Value Assessment Study at Facilities Plan Amendment Phase

Coos Bay Wastewater Treatment Plant No. 2
City of Coos Bay, Oregon

March 2012

Figure 3-2– Proposed Plant Layout per Option 1

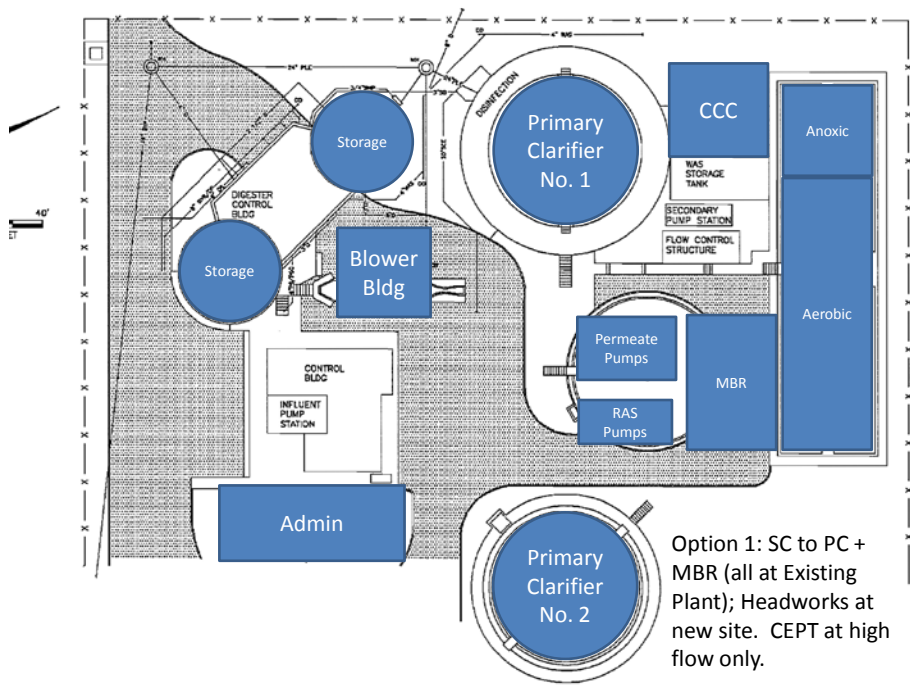
This alternative would use existing infrastructure to accommodate future flows and loads. **Figure 3-2** shows a proposed plant layout for Option 1, and **Figures 3-3 and 3-4** are schematic process flow diagrams for non-peak

and peak flows, respectively. The secondary clarifiers would be modified to primary clarifiers. This has the added benefit of eliminating the intermediate pump station at the site. The existing aeration basins would be modified to include an anoxic zone and aerobic zone. A separate tank for housing the membranes of a membrane bioreactor (MBR) would be constructed, in part to help with project constructability. The operating water level within the existing aeration basin would be raised to use more volume of the tank (approximately 4 foot increase). There is sufficient volume to accommodate the process (confirmed by CH2M HILL's Pro2D™ model). The MBR would be sized for the maximum month dry weather flow.

The primary clarifiers would be allowed to run as chemically enhanced primary treatment (CEPT) during peak wet weather flows that are beyond the peak capacity of the MBR. This means, that a coagulant such as alum would be added upstream of the primary clarifiers. The coagulant forms polymeric compounds that agglomerate and trap suspended solids within the wastewater, causing more solids to settle in the clarifiers. The portion of flow that cannot be handled by the MBR would be blended with MBR permeate, disinfected, and discharged. The blended effluent would meet all permit requirements prior to discharge.
